STAFF REPORT
COMMUNITY DEVELOPMENT DEPARTMENT

HEARING DATE: 2/6/2024
TO: Mayor & City Council
FROM: Sonya Allen, Associate Planner
208-884-5533
SUBJECT: Graycliff Estates No. 5
[FP-2023-0029](#)
LOCATION: Generally located south of W. Harris St.
and west of S. Meridian Rd., in the SE
1/4 of Section 25, T.3N., R.1W.

Final Plat consisting of 39 building lots and two (2) common lots on 5.86 acres of land in the R-8 zoning district for the fifth phase of Graycliff Estates Subdivision.

B. Final Plat (dated: 11/2/23)

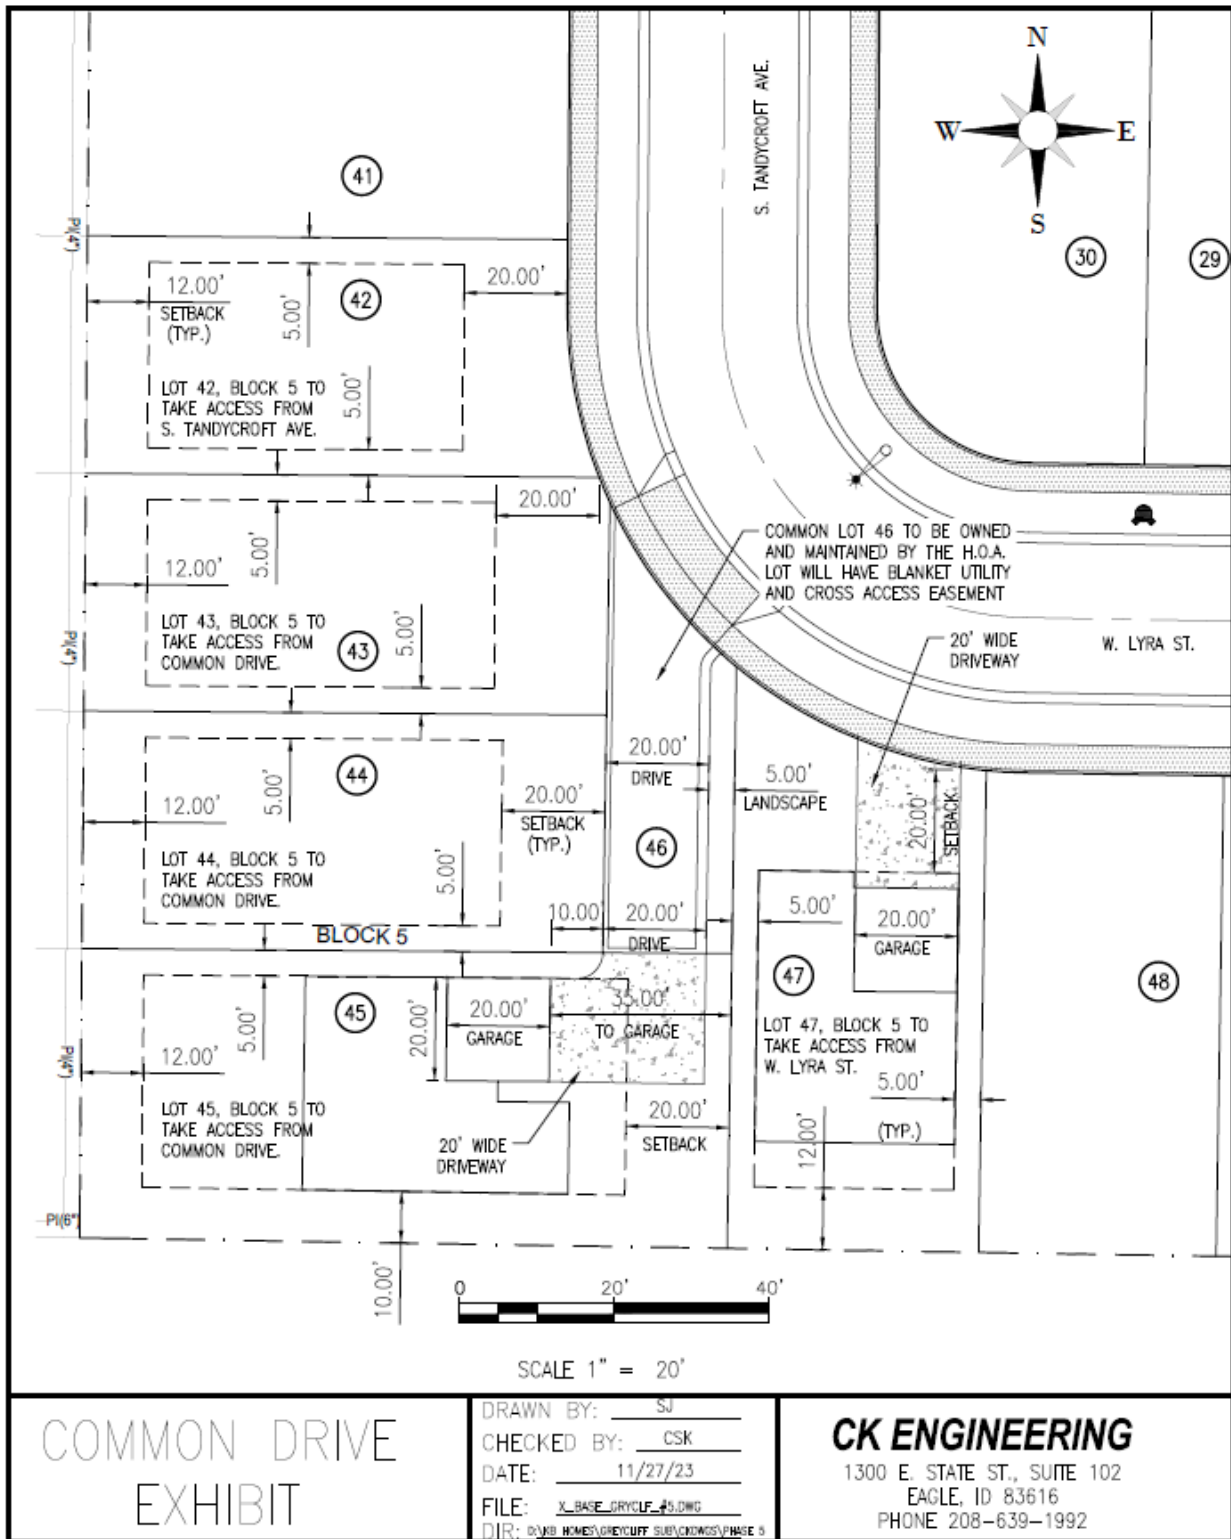
3. Prior to submittal for the City Engineer's signature, have the Certificate of Owners and the accompanying acknowledgement signed and notarized.
4. The final plat prepared by Land Solutions, stamped by Clinton W. Hansen, dated: 11/2/2023, included in Section V.B shall be revised as follows:

- a. Note #10: Include the recorded instrument number for the ACHD temporary license agreement.
 - b. Legend: Include the recorded instrument number of the ACHD permanent easement line.*A copy of the revised plat shall be submitted with the final plat for City Engineer signature.*

LANDSCAPE
PLAN - AREA 3

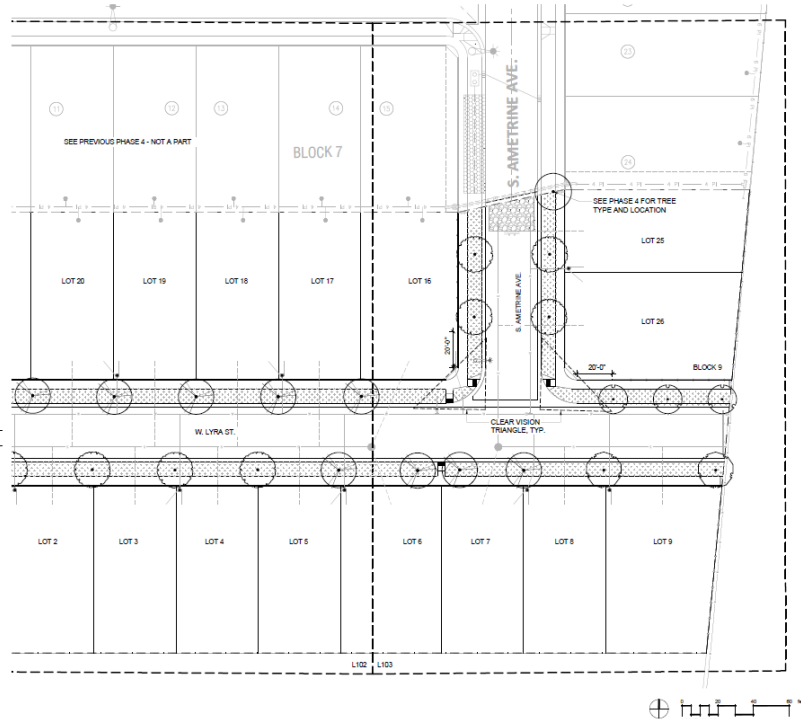
5. The landscape plan prepared by Stack Rock Group, dated 10/31/2023, included in Section V.D, shall be revised as follows:
 - a. Depict a 5-foot wide landscape strip planted with shrubs, lawn or other vegetative groundcover along the east side of the common driveway on Lot 46, Block 5 in accord with UDC [11-6C-3D.5](#).

- b. Include calculations for street trees planted within parkways (total linear feet of parkways and required vs. provided number of trees – 1 tree is required per 35 linear feet of parkway minus 26' for each driveway) as set forth in UDC [11-3G-3B.4](#).*A copy of the revised plan shall be submitted with the final plat for City Engineer signature.*
